111D Goldhurst Terrace  
London  
NW6 3HA

**My wife and I wish to formally object to the proposal to alter and extend Unit 1, 109 Goldhurst Terrace under planning application 2015/4386/P.**

*Existing roof line mapped on to Proposed Front Elevation and Proposed Side Elevation*

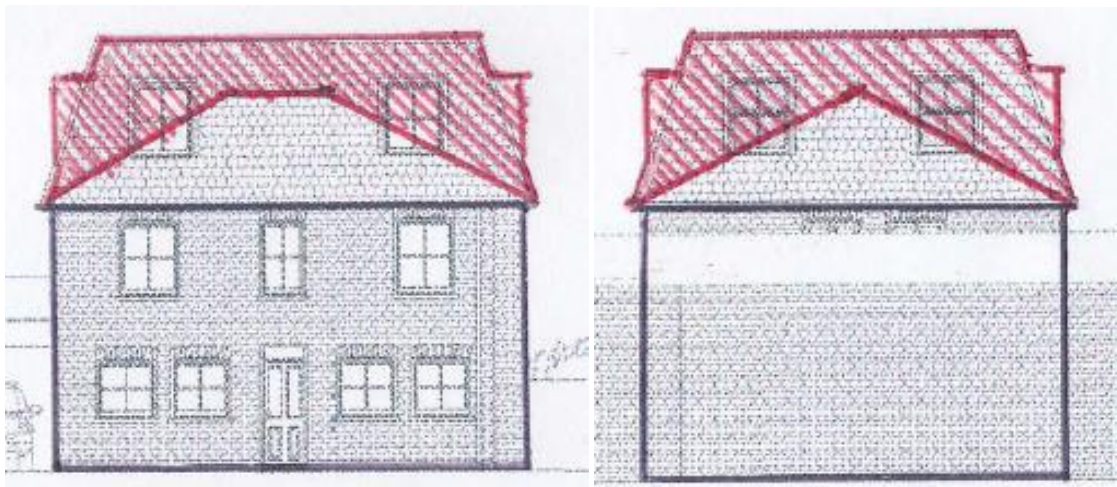
- a) In response to part 10 of the application, the applicant indicates that the site cannot be seen from a public road, public footpath, bridleway or other public land; however as the attached photograph shows (see page 4) the site is clearly visible from the junction of Fairhazel Gardens and Fairfax Place.
- b) In response to part 11 of the application, the description of the proposed roof materials suggests that *only* roof slates will be used; however i) roof slates could not be used to cover the flat section of the proposed flat-topped mansard; and ii) a glass light well is also shown to cover a large proportion of the flat-topped mansard, the composition of which has not been specified here.

The scale of the proposed roof alterations, which include a 71.3cm increase in height, will significantly increase the visual bulk of the existing property so as to overwhelm surrounding properties, including ours. We would strongly object to *any* proposal that increases the height of the roof and/or deviates from the current hipped roof construct. Firstly, the new flat-topped mansard would directly overlook and overshadow the aforementioned garden.

Unit 1, 109 Goldhurst Terrace also falls within the South Hampstead Conservation Area. Section 7.16 of the respective Character Appraisal and Management Strategy (CAMS) document states that "*alterations should not result in increased visual bulk to the roof, nor should they draw more attention*". The proposed alterations *do* result in increased visual bulk and *do* draw more attention (see attached sketches on page 4) and should therefore be deemed unacceptable.
